RE: Mission Ridge Master Planned Resort Expansion

**Draft Environmental Impact Statement Concerns**

Clip from GN Northern Geotechnical Report showing the new road eliminating parking in the lower and third lots.

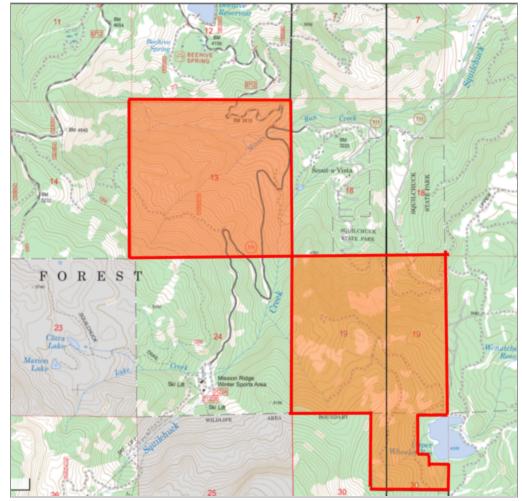
3. Third, the concept of <u>on-site</u> parking implies getting to park at the ski area (not at an off-site day-use lot, 1 mile and two lift rides away from the ski area). The proposed project will extend the Mission Ridge road through the existing lower and third parking lots, eliminating 100-200 spots. Thus, the project results in LESS On-site parking. This does not solve the stated problem of insufficient on-site parking.

Off-site parking similar to the project proposal could be created without giving up current on-site spots, and with much less environmental disturbance, by creating new parking on the newly acquired section 13, which has low angle terrain on both sides of the road about a mile downhill from the current parking lot. The travel distance from a Section 13 alternate parking lot to the ski area would be about the same as the distance to the proposed off-site day-use lot at the development. However, the proposed off-site day use lot requires a massive road construction project across public land, and the Section 13 solution does not. The map below shows the Section 13 land owned by the developer on which additional parking could be created.

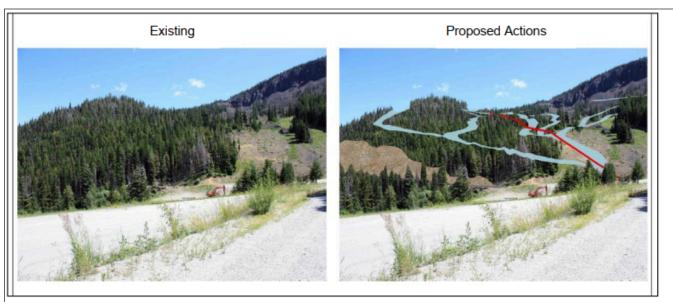
However, the proposed access cuts a brand new road across severe sideslopes with un-mitigatable visual impacts (see EA clips below). The alternative access Route Option 1 described in the applicant's Aegis Engineering 2023 Secondary Access - Review of Options report (Appendix D to the DEIS) traverses mild slopes with no cross slopes along existing roads at a significantly lower environmental cost and decreased level of environmental degradation.

The Aegis Engineering Option 1 secondary access is less impactful than the proposed main access road and would make a reasonable alternative access to the development. The DEIS should be revised to include additional alternatives that could feasibly attain or approximate the proposal's objectives on the same site, but at a lower environmental cost. Included in these additional alternatives should be a viable alternative to the proposed main access road.

DEIS figure 4.2-6 indicating high or very high wildfire hazard potential in and north of the development and encompassing the whole of the single egress road

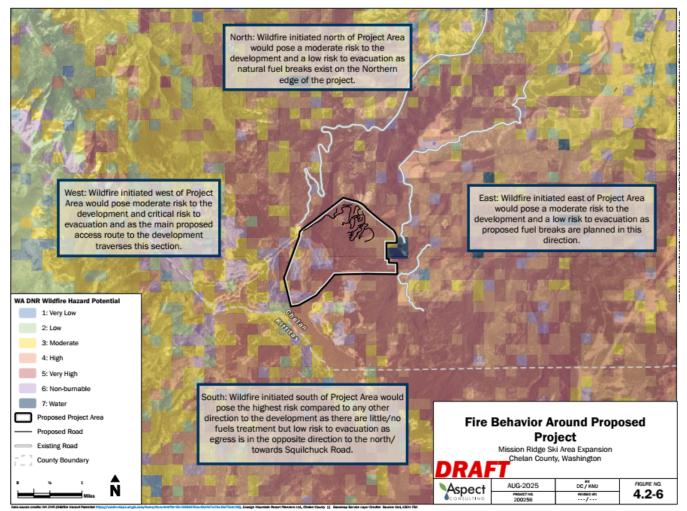
The DEIS states that a fire occurring to the north of the project (downhill and towards Wenatchee) will pose "...a moderate risk to the development and a low risk to evacuation." DEIS figure 4.2-6 shows the majority of land within and to the north of the project as High or Very High Wildfire Hazard Potential. A fire that starts to the north (downhill from the development) will both block the egress road, and rush uphill with elongated flame lengths (as compared to a fire moving downhill). The unsubstantiated assertion that a fire moving uphill and blocking egress poses moderate and low risk to the development requires further analysis. Similarly, the DEIS states that a wildfire approaching from the south (uphill from the development) would pose high risk to the development but "... low risk to evacuation as egress is in the opposite direction, to the north/towards Squilchuck Road". This assertion ignores ember cast that throws fire forward which could ignite new fires downhill from the development thereby closing the egress, and this analysis ignores the severity of wildlife that would likely occur on the upper portion of Mission Ridge. Alexander, M.E., & Cruz, M.G. (2014). Crown fire behavior in conifer forests. Fire Management Today, 73(4), 24-27. U.S. Department of Agriculture, Forest Service. The DEIS should be revised to substantiate the unlikely claim that a wildfire originating to the north of the development poses "...a moderate risk to the development and a low risk to evacuation" and that there would be "low risk to evacuation" caused by a fire approaching from the south.

Wetlands locations circled in orange and yellow. Clip from <u>Streams and Wetlands and Riparian Area Plan A-2b 2022</u> <u>application maps</u>

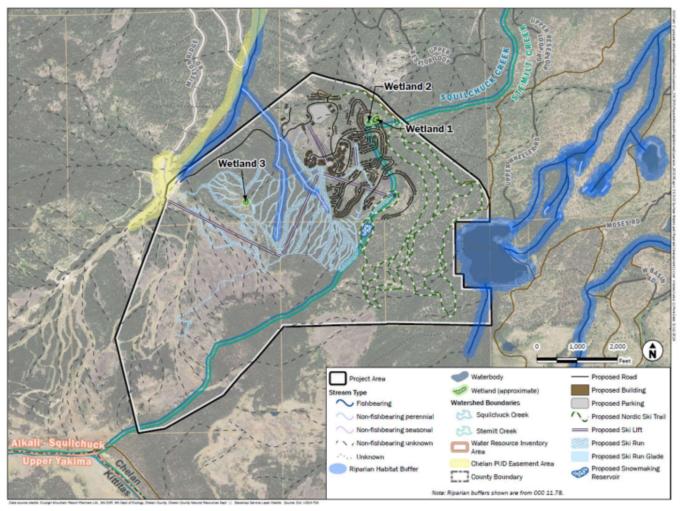
This is not true. The two identified wetlands in the development footprint are shown to be covered by streets and housing units. The wetlands have already been damaged by the developer during a 2025 logging operation. The following photos show heavy machinery tracks actually traveling in and through both seasonal ponds and category III wetlands.

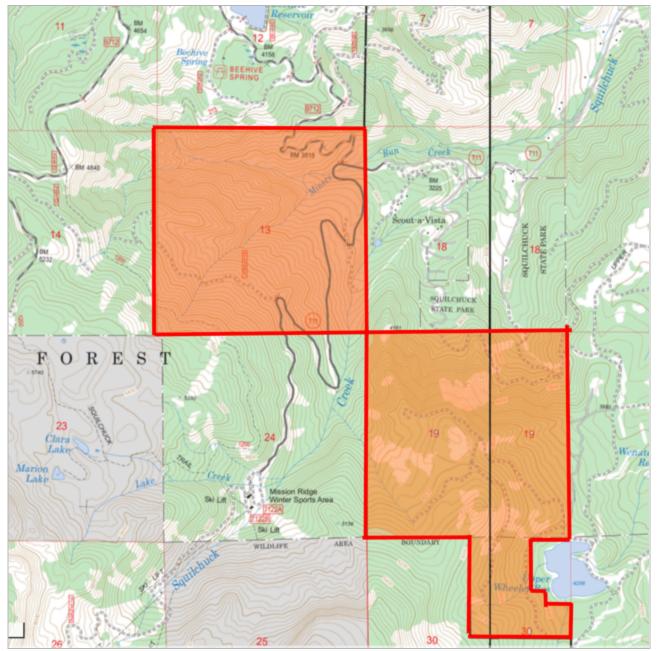
The DEIS has identified in this section that the project utility improvements (water and power) could accommodate growth beyond the proposed project area. Specifically, this is likely to happen on both sides of the Mission Ridge Road on property purchased in January of 2025 by the owner of the development property (see map below). The DEIS should investigate the potential sprawl enabled by the project and discuss this conflict with County Code.

The development property is on highlighted Section 19. The highlighted section 13 is a candidate for sprawl enabled by the utility extensions associated with the proposed project.

Snip from DEIS figure 5.6-3 - Proposed Transportation Infrastructure Improvements in and Near Project Area

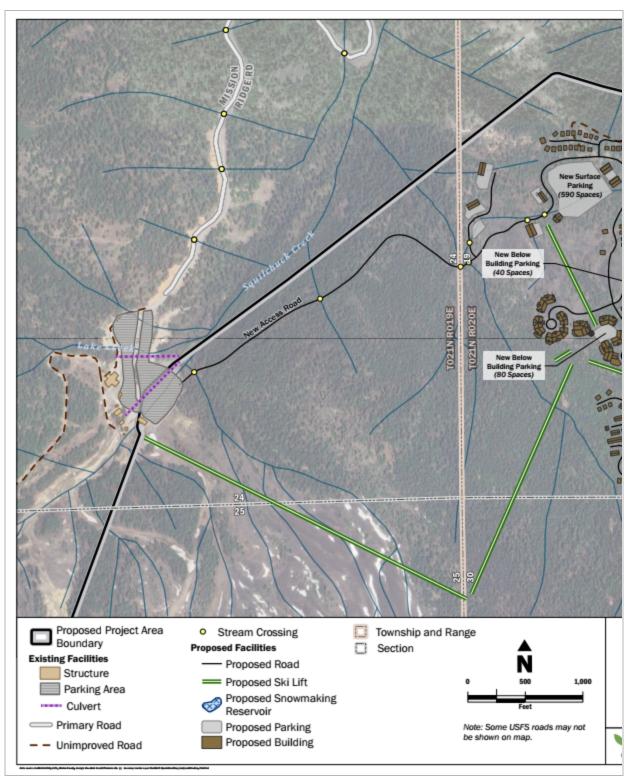
DEIS Section 5.2.3.1, Direct Impact from Construction discusses building the new County Maintained driveway road through the Mission Ridge parking lot and across Squilchuck and Lake Creek, which are both diverted under the existing parking lot in culverts: "Construction of the proposed County-maintained access road, including possible replacement of existing culverts underlying the Mission Ridge parking lot, would be located within the wellhead protection area." The Lake Creek and Squilchuck culvert are shown in purple in the graphic below.

creek is fish-bearing. The DEIS should be revised to include Lake Creek in the Project Area Surface Water Summary. Lake Creek should be designated as a fish bearing perennial stream. If field studies are necessary for designation as a fish bearing stream, then those studies should be included in the DEIS process.

Edited snip from Revised Site Plans showing proximity of proposed driveway road and Squilchuck Creek

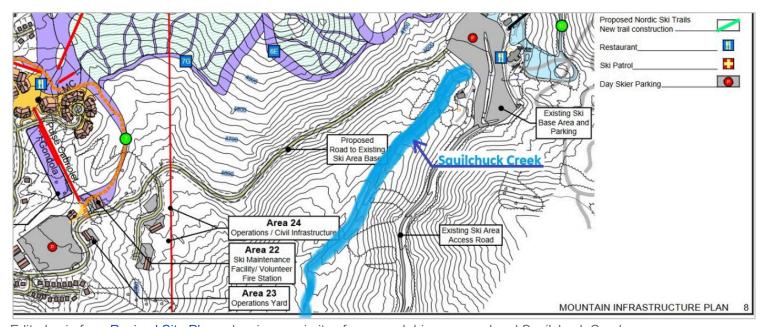
The DEIS states that "impacts to perennial fish-bearing reaches of Squilchuck Creek may occur during construction in two areas, at the existing Mission Ridge parking lot and along the PUD utility corridor." Omitted are impacts to perennial fish-bearing Lake Creek at the existing Mission Ridge parking lot, and impacts to Squilchuck Creek along the first portion of the driveway access road as it exits the Mission Ridge parking lot, where the road is within 200 feet of Squilchuck Creek. There may be additional sections of the access road that encroach into the 200 foot buffer. Preliminary design of the access road will be required in order to determine what sections of road construction encroach into the 200 foot buffer. The DEIS should be revised to include preliminary design of the access road in order to determine what sections of the road encroach into the 200' buffer around Squilchuck Creek, and to include impacts to perennial fish-bearing Lake Creek at the Mission Ridge parking lot.
